IEEE P802.15 Wireless Personal Area Networks

Project	IEEE P802.15 Working Group for Wireless Personal Area Networks (WPANs)	
Title	TG3 SB1 text for various resolution	
Date Submitted	[6 February, 2003]	
Source	[James P. K. Gilb] [Apparent Technologies] [15373 Innovation Drive, #210, San Diego, CA 92129]	Voice: [858-485-6401] Fax: [858-485-6406] E-mail: [gilb@ieee.org]
Re:	[]	
Abstract	[This document is a summary of some of the more complex comment resolutions for SB1.]	
Purpose	[To provide a concise summary of comment resolutions that are too complex to represent in the comment database.]	
Notice	This document has been prepared to assist the IEEE P802.15. It is offered as a basis for discussion and is not binding on the contributing individual(s) or organization(s). The material in this document is subject to change in form and content after further study. The contributor(s) reserve(s) the right to add, amend or withdraw material contained herein.

1 **1. Text for selected resolutions**

29
30
31
32
33
34
35
36
37
38
39
40 **Figure 1—PNC sending the piconet services command to a newly associated DEV in**
41 **response to a request in the association proces.**
42

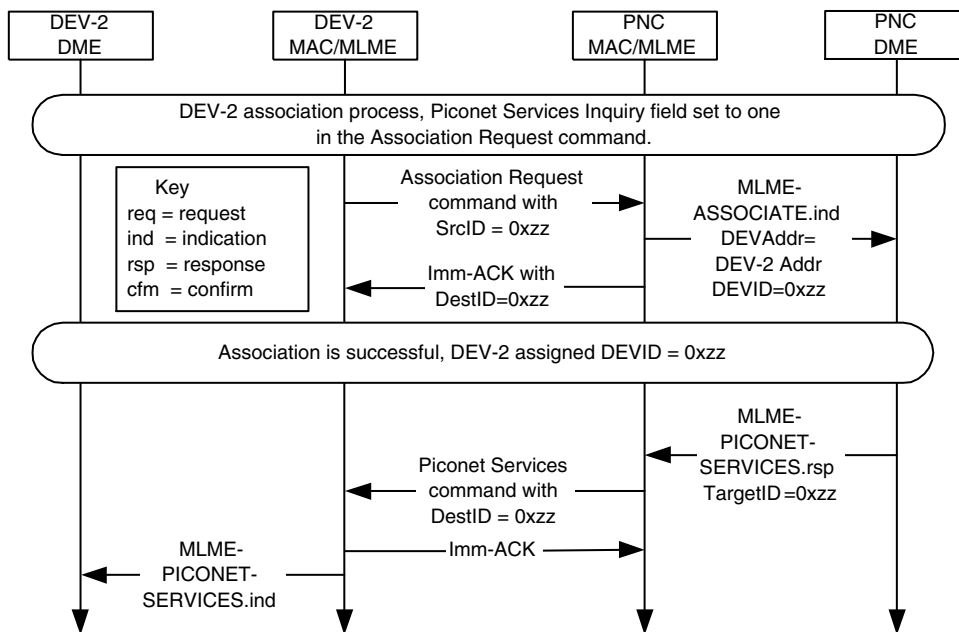
8
9 Accept in principle “Change to ‘If the DEV sets the piconet services inquiry bit, the PNC shall send the
10 piconet services command, 7.5.4.6, with DestID set to newly assigned DEVID after that PNC has received
11 the second Association Request command from the DEV, {xref }. This process is illustrated in {figure xx},’
12 and add new MSC as shown in 03/032r10.”
13
14
15
16
17
18

Figure 3—MSC for the handing over control of a private, pseudo-static CTA

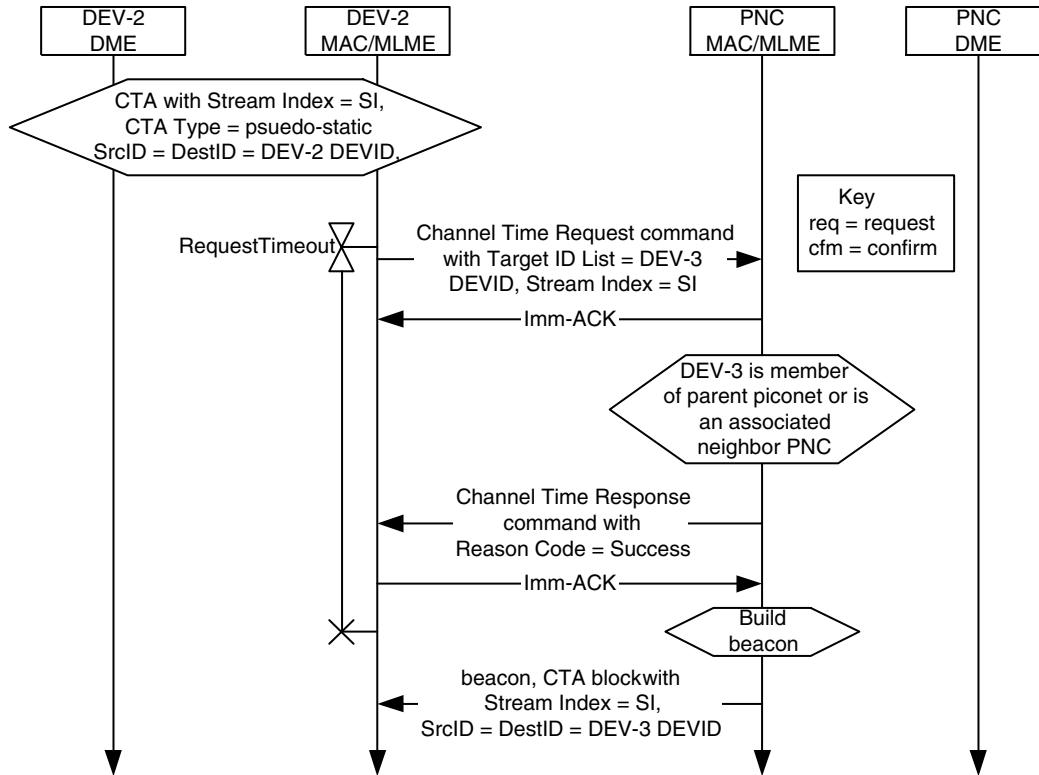
CID 1, CID 215, CID 352 and CID 139. Accept in principle “Add the ability to handover the dependent PNC as indicated in 03/032r8.”

A dependent PNC, the originator DEV, may handover control of the dependent piconet's CTA to another DEV, the target DEV, in the parent piconet. The target DEV shall either be a member of the piconet or a DEV that has associated as a neighbor PNC, {xref association}. To handover control of the dependent piconet's CTA, the originator DEV shall send a Channel Time Request command to the parent PNC with the following parameters:

- The Num Targets field set to one.
- The Target ID List field containing the DEVID of the target DEV that is to receive control of the CTA
- The Stream Request ID set to zero.
- The Stream Index of a CTA that has already been allocated to the dependent PNC as a private, pseudo-static CTA.
- All other fields set to the same values as in the last successful Channel Time Request for this Stream Index.

If the target DEV indicated in the Target ID List is either a member of the parent piconet or is a associated neighbor PNC and the Channel Time Request command has the correct entries as indicated above, the parent PNC shall grant the request to change the source and destination for the stream and shall send a Channel Time Response command to the originator with the Reason Code set to 'Success'. The PNC shall continue to place the CTA block for the allocation in the beacon but shall change the SrcID and DestID to be equal to the target's DEVID. Once the PNC has changed the SrcID and DestID in the CTA block, the target DEV will have gained control of the CTA and will be allowed to request modifications or the termination of the allocation.

If the target DEV is not a member of the piconet and it is not an associated neighbor PNC, the parent PNC shall reject the request and shall send a Channel Time Response command to the originator with the Reason Code set to either 'DEV unassociated' or 'DEV unauthenticated' depending on the status of the Target DEV.

If the Channel Time Request command has improper entries, e.g. the Stream Index does not exist or the Stream Index is not associated with a private, pseudo-static CTA, then PNC shall reject the request and shall

send a Channel Time Response command to the originator DEV with the Reason Code set to 'Request denied'.

The MSC for the handover of the control of a private, pseudo-static CTA is illustrated in Figure 3.

Figure 4—Successful PNC handover in a dependent piconet.

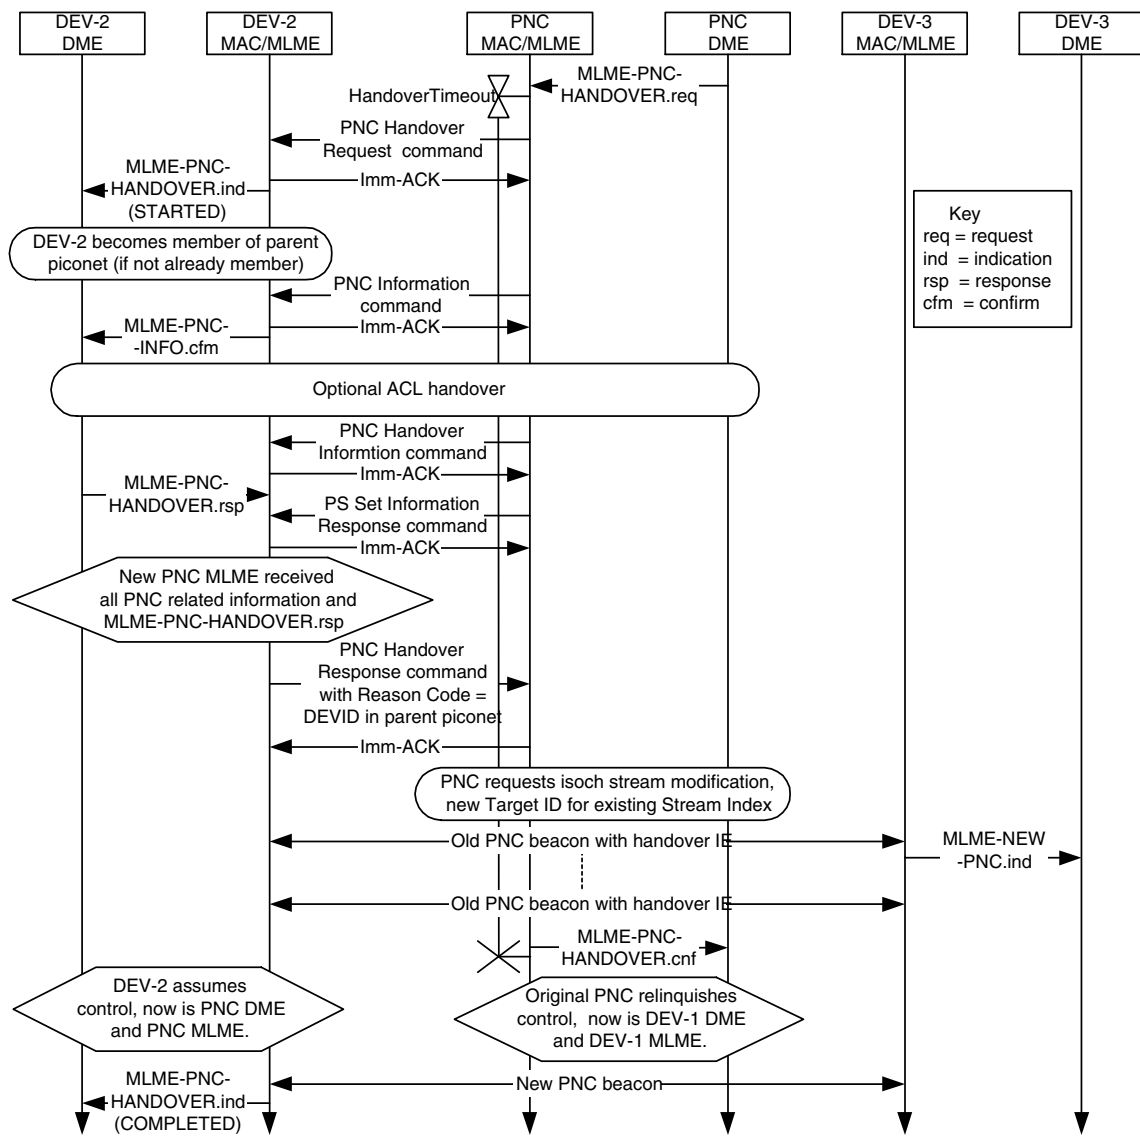
The dependent PNC handover process begins in the same manner as a regular PNC handover, {xref 8.2.3}, with the current PNC sending the PNC Handover Request Command to the target DEV that it has selected to

become the new PNC, as shown in Figure 4. In this and the two subsequent figures, the identities PNC, DEV-2 and DEV-3 are all relative to the dependent piconet and not the parent piconet. If the target DEV is not a member of the parent piconet, then that DEV shall begin the association process to join the parent piconet and, if required, authenticate with the parent PNC. The target DEV may request to associate with the parent piconet as either a neighbor PNC or as a member of the piconet. While target DEV is attempting to join the parent piconet, the current dependent PNC shall send the target DEV the information about all of the DEVs with the PNC Information command, all of the current channel time requests with the PNC Handover Information command and the power save information, if any, using the PS Set Information Response command. The target DEV may also request the transfer of any ACL data at this point using the ACL Information Request command. Note that the transfer of this information will not interfere with the target DEV's association and authentication process because the former occurs only during time reserved for the dependent piconet while the latter only occurs during time reserved for the parent piconet.

Figure 5—Failed dependent PNC handover when target DEV fails to join parent piconet.

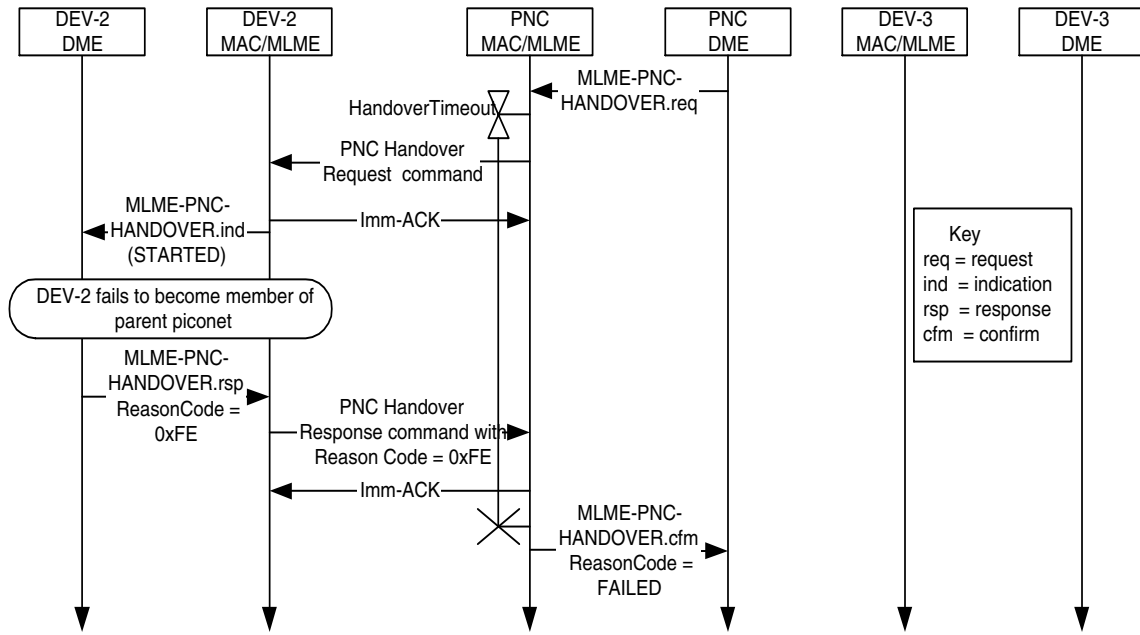
If the target DEV fails to join the parent piconet as either a regular DEV or as a neighbor PNC, it shall send the PNC Handover Response command to the dependent PNC with the Reason Code set to 'Handover

refused, unable to join parent piconet' as illustrated in Figure 5. The target DEV may refuse the handover at any time while the dependent PNC is sending over the information about the piconet.

Figure 6—Failed dependent PNC handover when control for the dependent piconet CTA is handed over in the parent piconet.

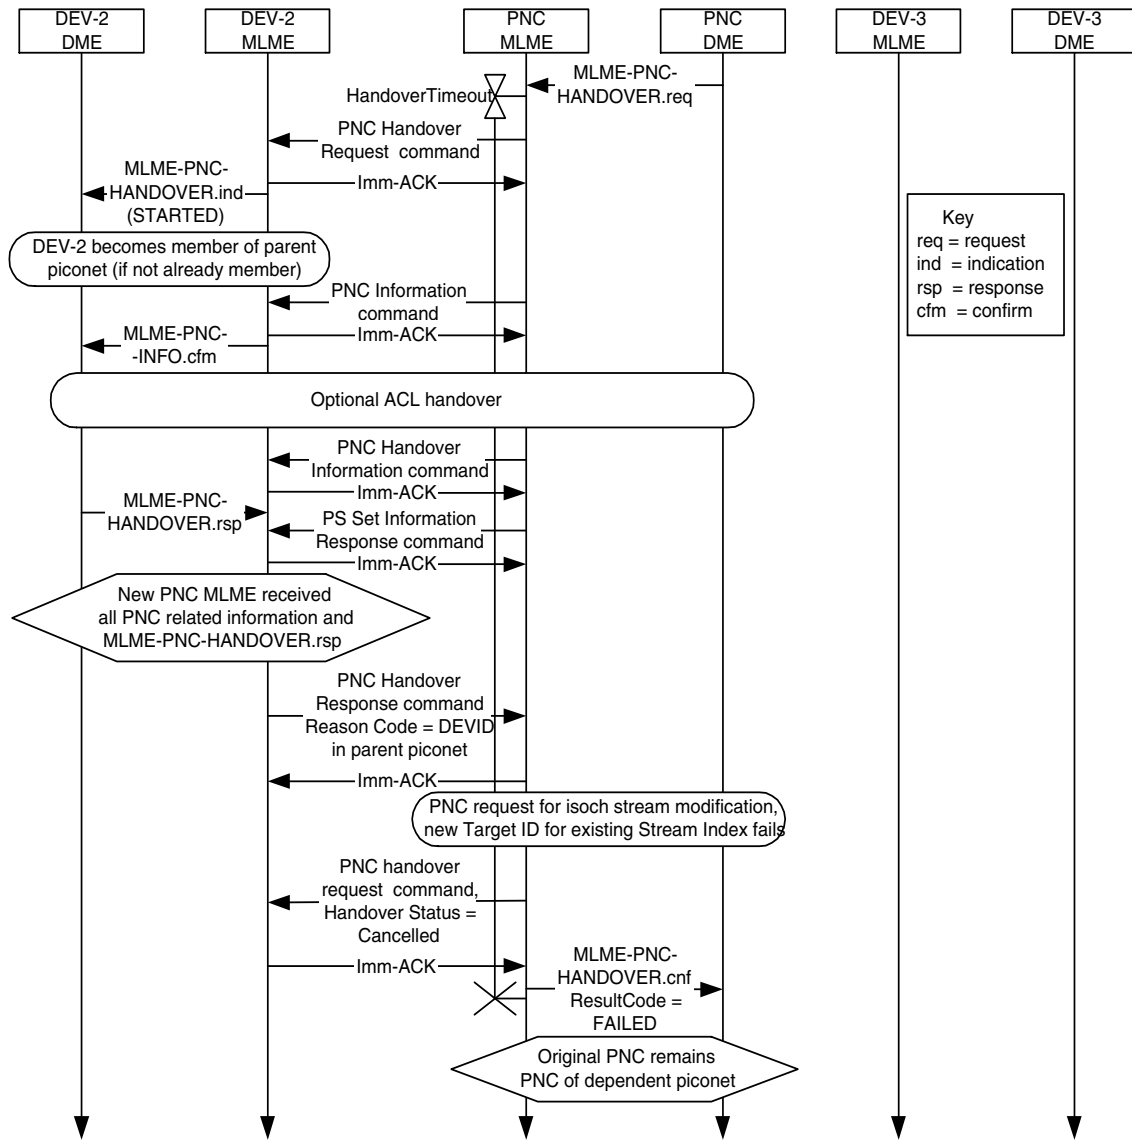
If the parent PNC rejects the request to handover control of the CTA to the new dependent PNC, the dependent PNC shall send a PNC Handover Request command to the target DEV with the Handover Status field set to 1 to indicate that the handover process is being cancelled, as illustrated in Figure 6.

Figure 7—Channel time request for frames with immediate ACKs

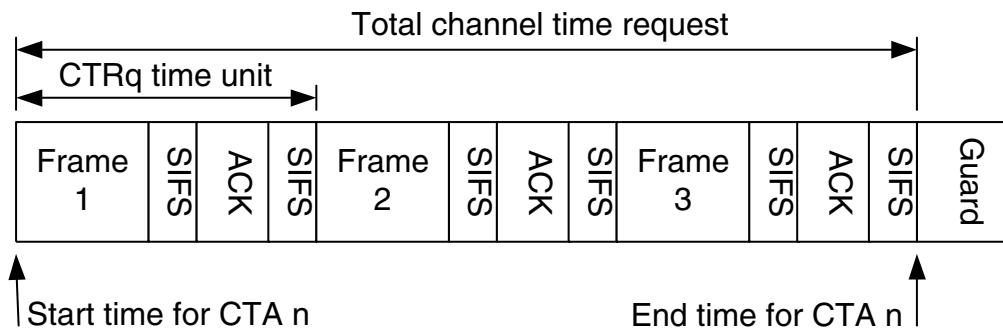
Accept in principle: “The inclusion of MIFS changed the CTR calculations, but the changes were not reflected in 8.4.4.6. 1)Change b3 in Figure 79 from “stream termination” to “MIFS CTRq TU”. 2)Replace page 152, line 12 with:

The requesting DEV shall include the frame transmission time, if known *a priori*, and the ACK transmission time, if used, and MIFS or SIFS time as appropriate per frame or ACK when calculating channel time requests. Figure 7 (was #108) shows an example of channel time being requested for a CTA where Imm-ACKs are used.

Figure 8—Channel time request with no ACKs

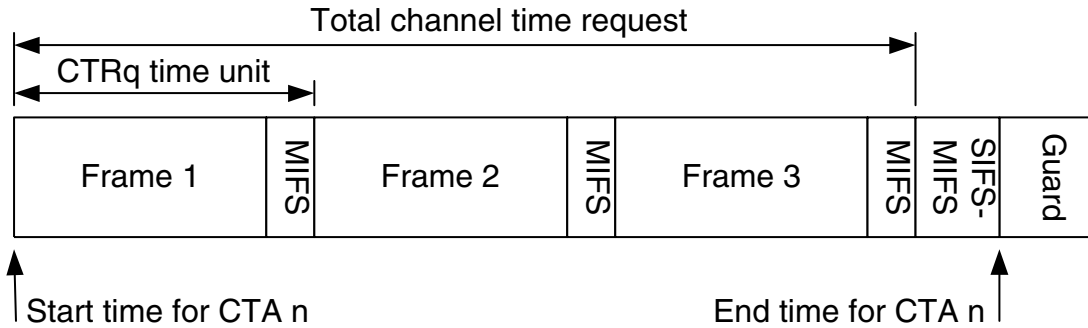
When No-ACK is used, the channel time request is calculated differently because there is a MIFS in between each frame in the CTA instead of a SIFS. A channel time request that uses a CTRq TU with MIFS instead of SIFS shall set the CTRq TU MIFS bit to one to inform the PNC that it must add a time equal to SIFS-MIFS to the end of the CTA. This ensures that there is a SIFS between the end of transmission in one CTA and the

start of the next. Figure 8 shows an example of a channel time request when no-ACK is used and the MIFS bit is set in the Channel Time Request command.

Figure 9—CTRq time unit covering multiple frames with CTRq TU MIFS = 0

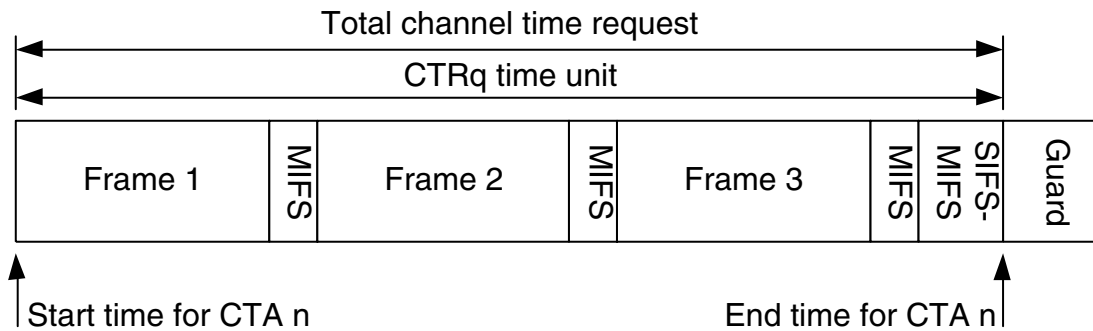
A CTRq TU in the CTA may cover more than one frame as shown in Figure 9. If the requesting DEV included SIFS-MIFS following the last MIFS as shown in Figure 9 it shall set the CTRq TU MIFS in the Channel Time Request to “0.” IF SIFS-MIFS is not included in the CTRq TU, the CTRq TU MIFS bit shall be set to “1” and the PNC shall add SIFS-MIFS to the CTRq TU to calculate the duration of the CTA. Figure 9 shows a multi-frame CTRq with the CTRq TU MIFS field set to 0.

Figure 10—CTRq time unit covering multiple frames with CTRq TU MIFS = 1

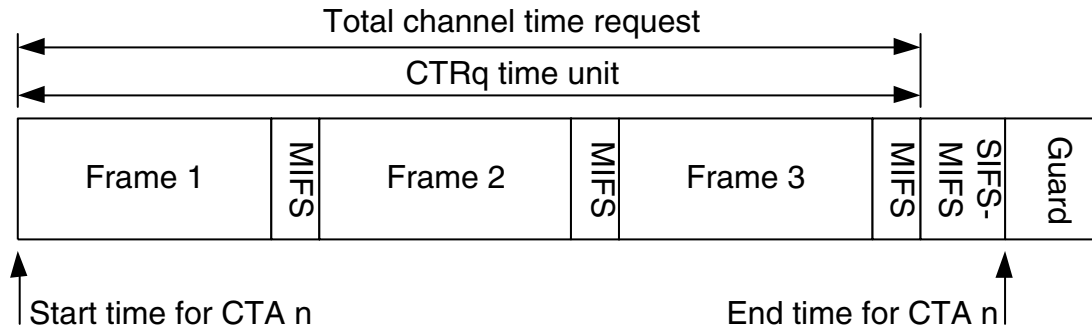
Figure 10 shows a multi-frame CTRq with the CTRq TU MIFS field set to 1.
